Re: Denial of Request for Incidental Boundary Change, Carbon County
Lease for No. 1 Slope, Kaiser Coal Corporation, Sunnyside Mines,
ACT/007/007, Folder #2, Carbon County, Utah

Re: Incidental Boundary Change
Carbon County Lease for No. 1
Slope - Sunnyside Mines
ACT/007/007

INCIDENTAL
BOUNDARY
CHANGE

DRAWING NO.
A1-0225

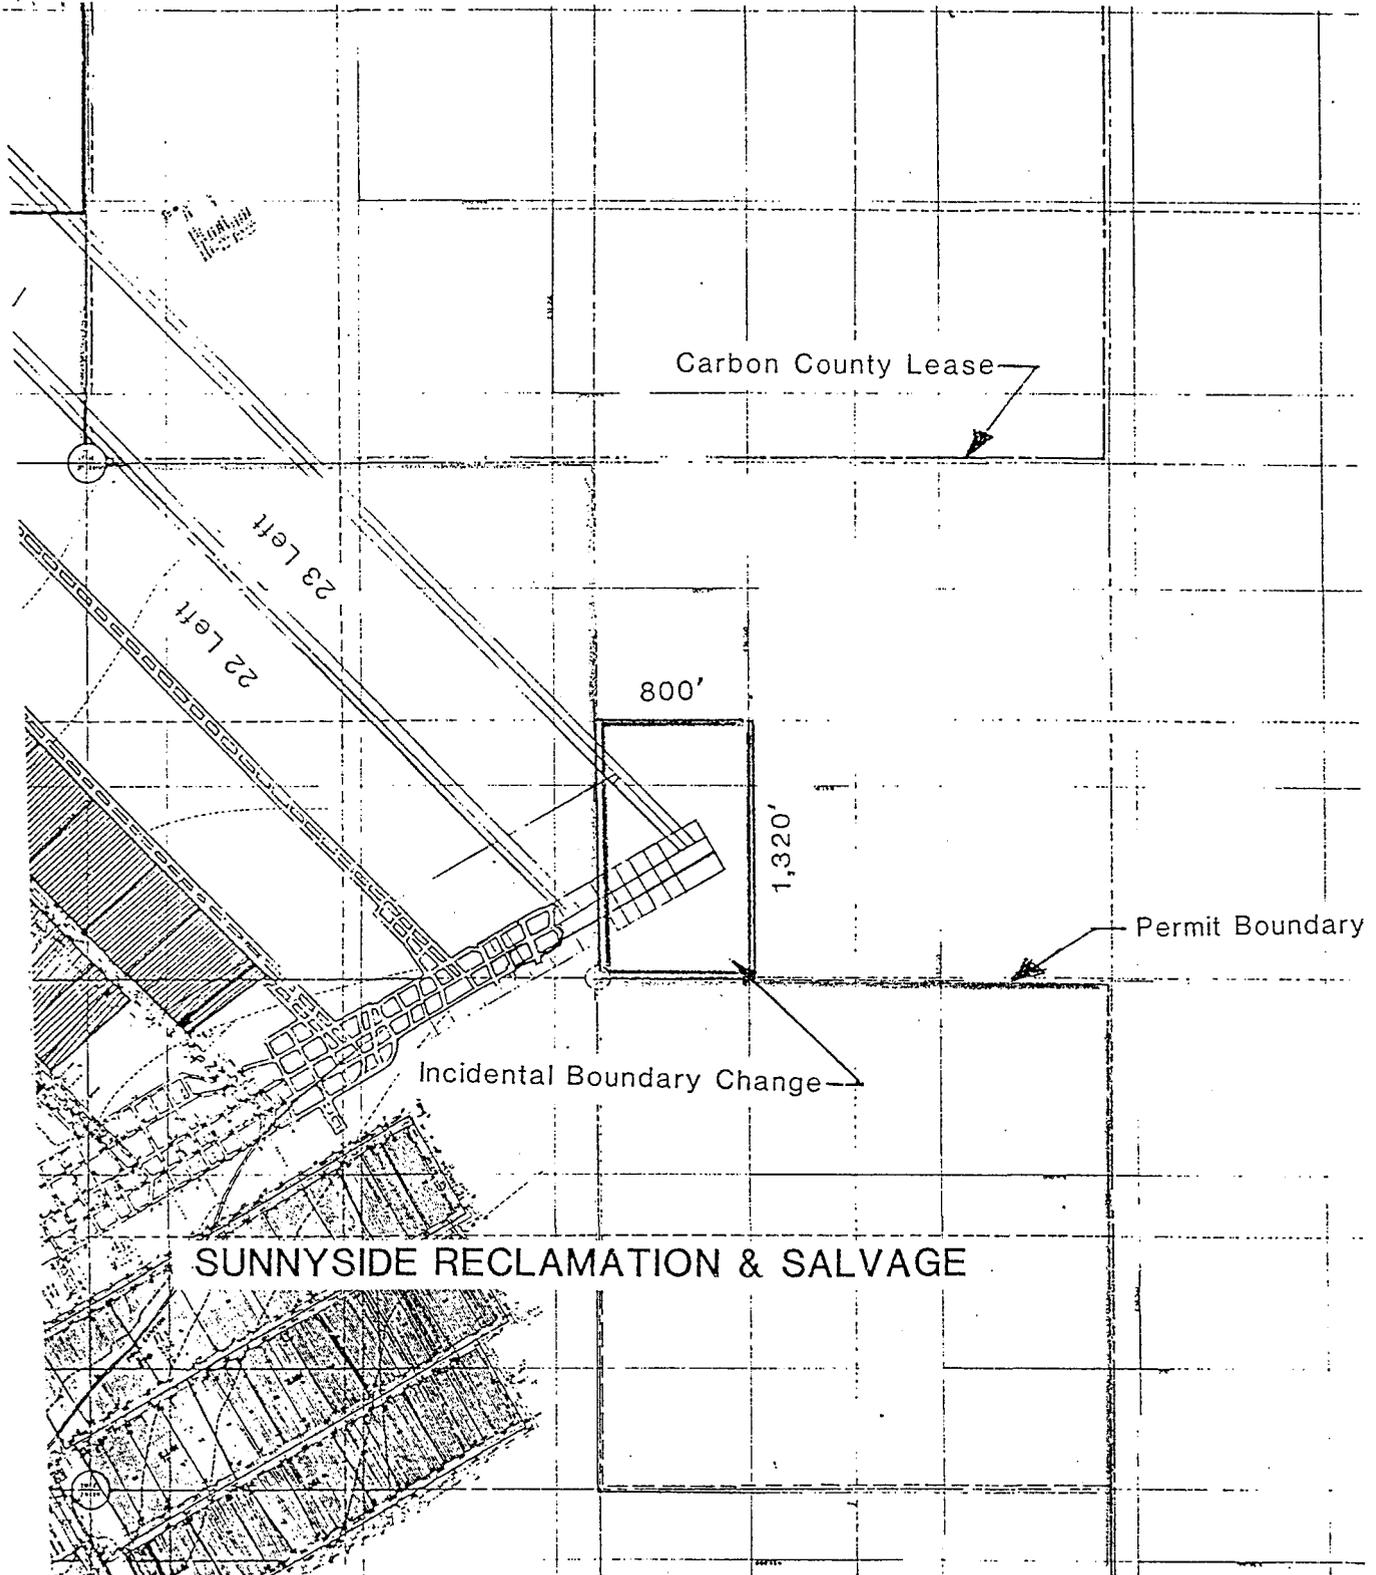
The Division is unable to approve the submitted request dated March 20, 1989, for an Incidental Boundary Change (IBC). Please be aware that IBCs may not exceed ten acres during a five-year permit term. Requests that exceed ten acres may be classified and reviewed as Significant Revisions. Accordingly, the additional request for an IBC at Sunnyside Mines must account for the area of land encompassed by the IBC approved October 4, 1988. More specifically, the submitted request for an IBC may not exceed 9.83 acres during this permit term.
